Response to Submissions

Lourdes Retirement Village Planning Proposal

95 Stanhope Road, Killara

Prepared on behalf of Levande

Figure 3: Existing village built form layout

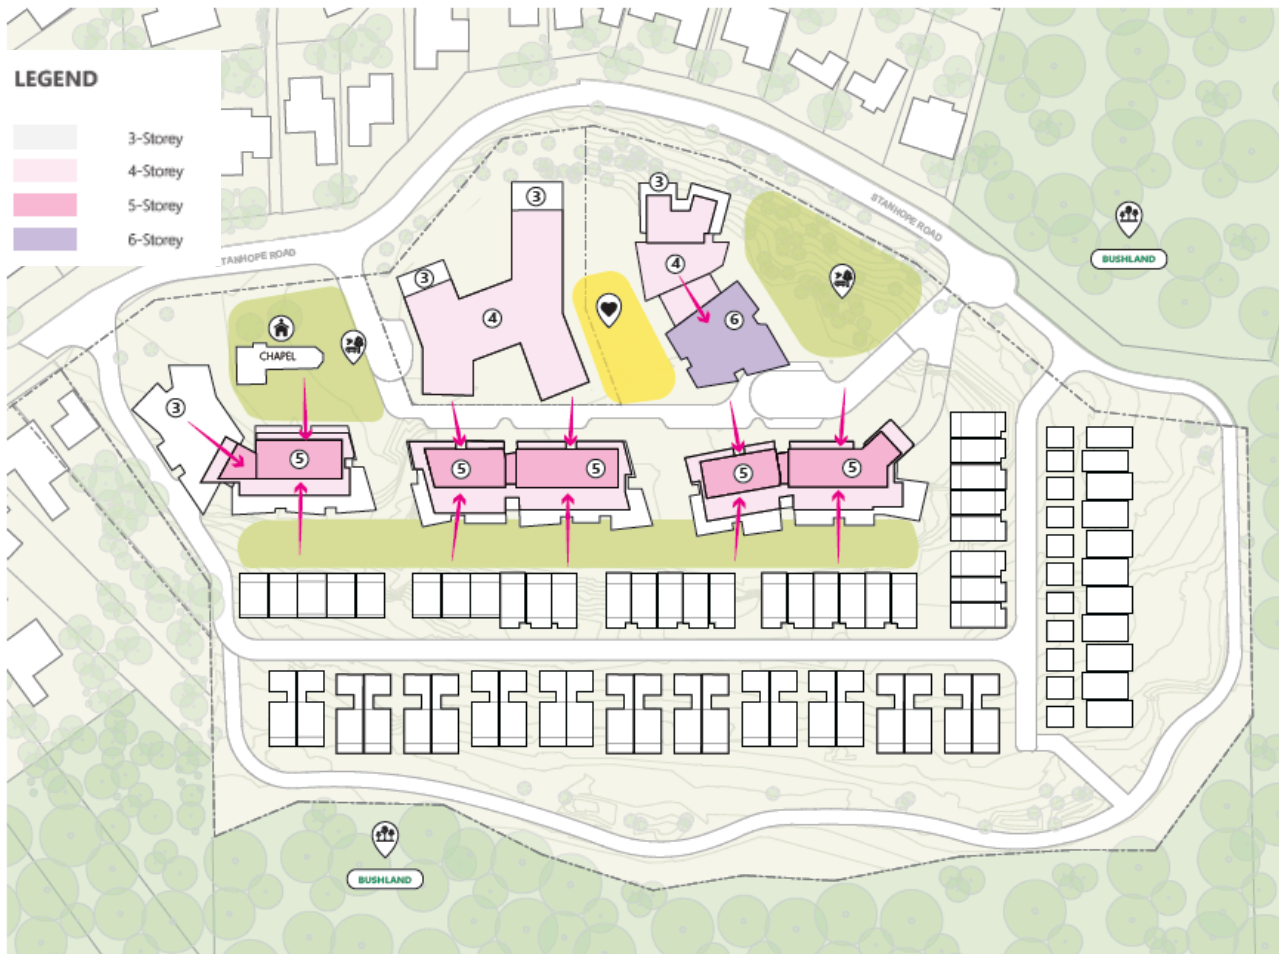
The exhibited Master Plan and amended Master Plan are shown in and Figure 1 and Figure 2 respectively and are also included in the Urban Design advice at Appendix A. Figure 3 shows the existing village layout.

Figure 4: Building height and upper-level setbacks

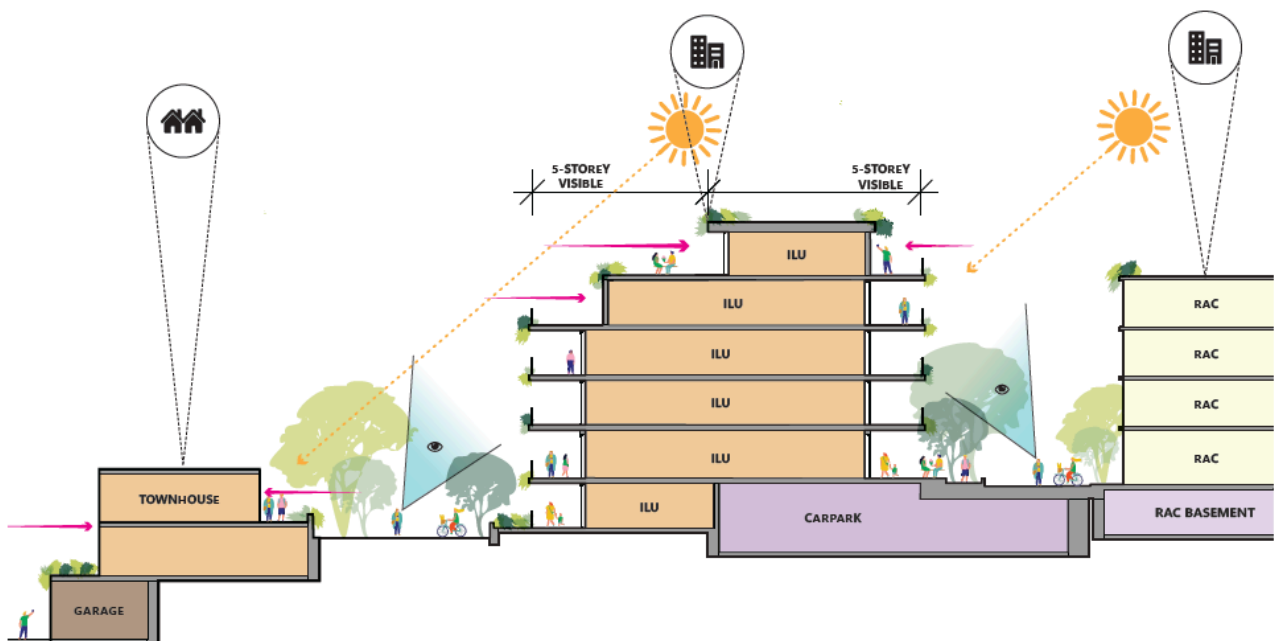
The changes in buildings heights and clarification of upper level setbacks is also illustrated at Figure 4, and Figure 5 highlights the proposed transition of scale across the site topography which seeks to minimise perceived height at ground level and maximise solar access.

Figure 6: Tree removal

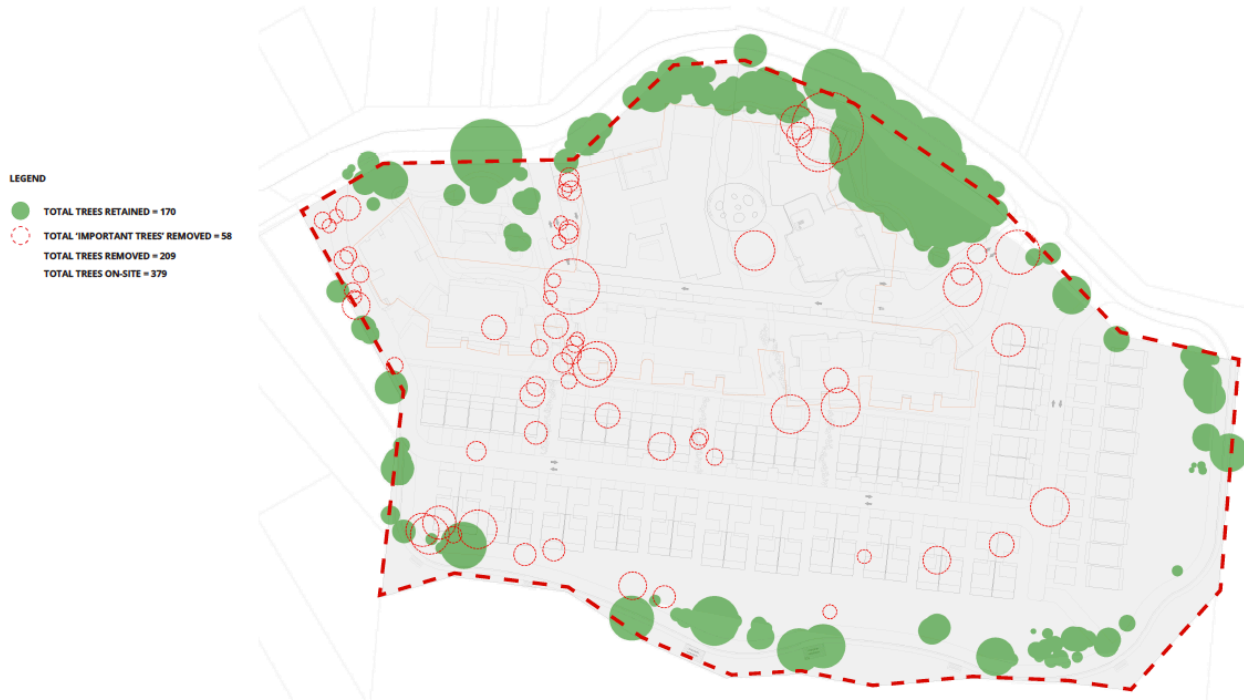
The updated Master Plan would result in removal of 209 trees compared to 233 under the exhibited Master Plan. This has been achieved through retention of additional trees around Headfort House and the southern and eastern perimeter of the site.

Figure 7: Tree planting

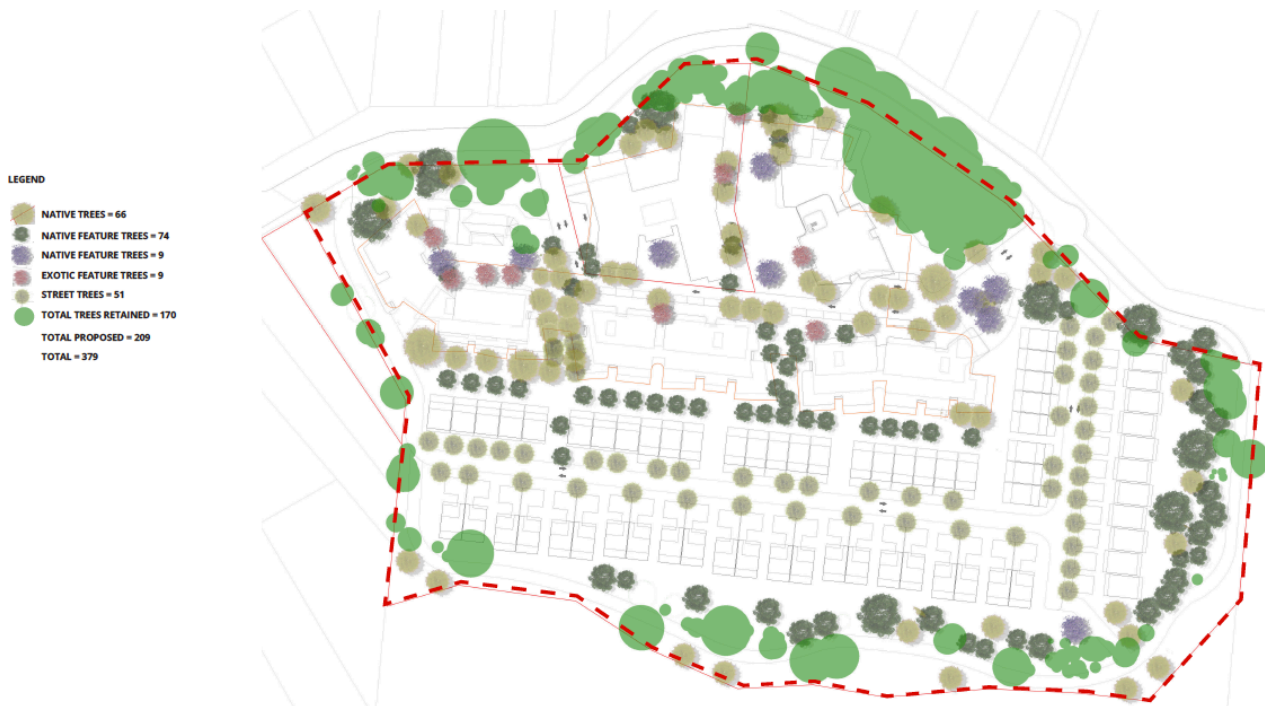
Of the 209 trees to be removed 58 are identified as significant trees with 151 being of low significance. A total of 170 trees would be able to be retained on site, with 209 trees proposed to be planted result in a total of 379 trees consistent with the existing number.

Figure 11: View P08 – Rosebery Road at the intersection of The Crescent looking south

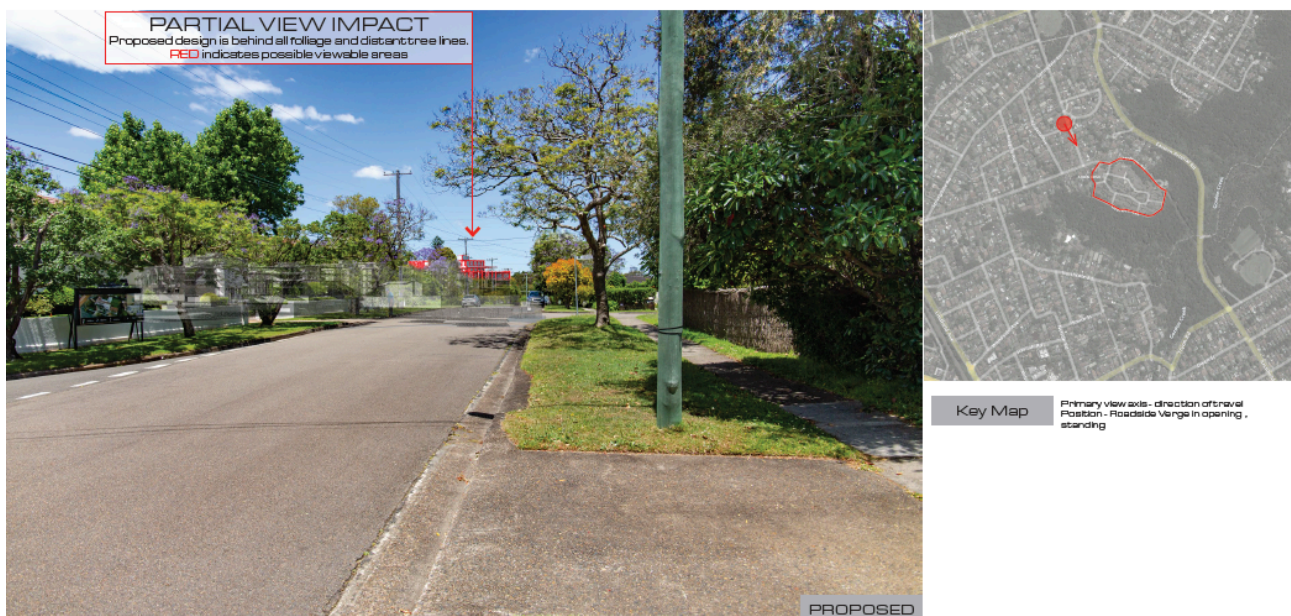
The tops of buildings will also be partially visible through and above foliage for longer range views from Stanhope Road at the intersection with Redgum Avenue looking east (Figure 10) and Rosebery Road at the intersection of The Crescent looking south (Figure 11). This is considered to be a minor impact.
